REPORT TO THE SUBDIVISION AND DEVELOPMENT APPEAL BOARD

DATE: July 8, 2021 ; September 16, 2021	APPEAL NO.: SDAB2021-0044 AB FILE NO.: DP2021-0070							
APPEAL BY: Murray Desrosiers and Kathleen Staniland								
FROM A DECISION OF THE DEVELOPMENT AUTHORITY where an	LAND USE DESIGNATION: R-C1							
Addition: Single Detached Dwelling (Balcony)	Discretionary							
was approved at <u>1411 22A Street NW</u>								
COMMUNITY OF: Hounsfield Heights/Briar Hill	DATE OF DECISION: May 21, 2021							
APPLICANT(S): Christine Boos	OWNER(S): Denny Kwan

Subject: Addition: Single Detached Dwelling (Balcony)

Address: 1411 22A ST NW

BALCONY PLAN

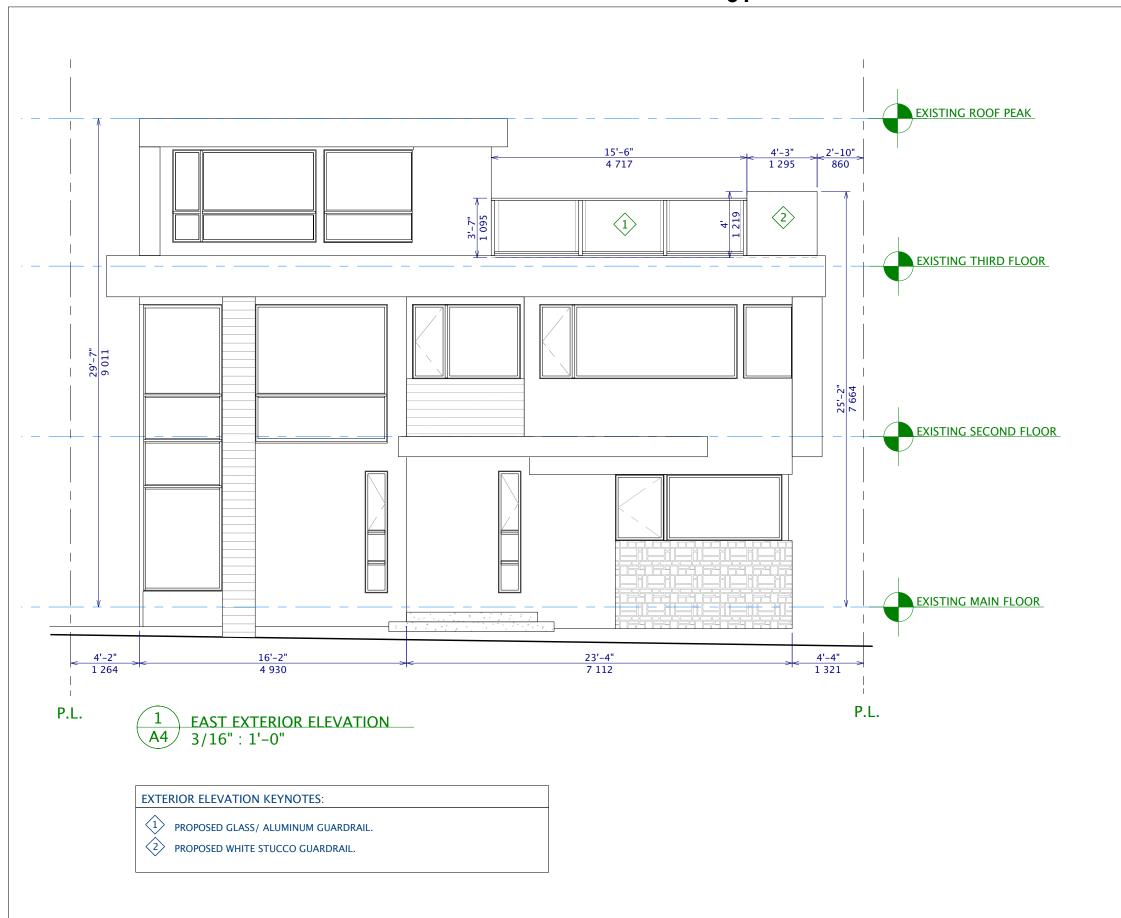
Bylaw Discrepancies							
Regulation	Standard	Provided					
340 Balconies	(1) Unless otherwise referenced in this Part, an open balcony must not project more than 1.85m from the building façade to which it is attached.	Plans indicate the balcony as projecting 5.22m (+3.37m) to 6.00m (+4.15m)					
Permitted C	Contextual Use Rules						
Regulation	Standard	Provided					
	N/A

The proposed change is a significantly sized rooftop patio. We are not necessarily opposed to this, but inadequate attention has been given to overlooking mitigation. This needs further review.

Bylaw Discrepancies		
Regulation	Standard	Provided
340 Balconies	(1) Unless otherwise referenced in this Part, an open balcony must not project more than 1.85m from the building façade to which it is attached.	Plans indicate the balcony as projecting 5.22m (+3.37m) to 6.00m (+4.15m) Please amend the drawings to reduce the projection of the balcony within the black lines as indicated on the image above

- e. It is noted that the glass rail on the west façade is consistent with the 2nd floor balcony below.
 - f. On the north façade, planters have been placed along the inside of the stucco, this move the user of the balcony away from the edge, thus promoting outward views, and preventing direct overlooking downward.

- g. A combination of planters and privacy screens are located along the south façade, moving the balcony user away from the balcony edge and discouraging direct overlooking.

View of proposed pergola with outdoor kitchen and seating benches

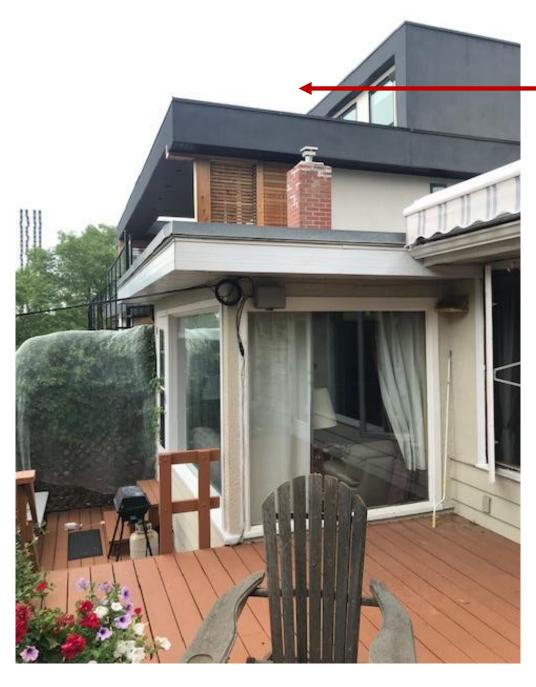
The proposed pergola is over-height and will add to the overall mass of the existing house. The pergola will be visible from the rear elevation and will give the house the appearance of a four-storey building from the rear. The pergola and screen wall and planters will definitely be visible from the deck of the neighbour to the south. The mass of the third storey will dominate the house to the south.
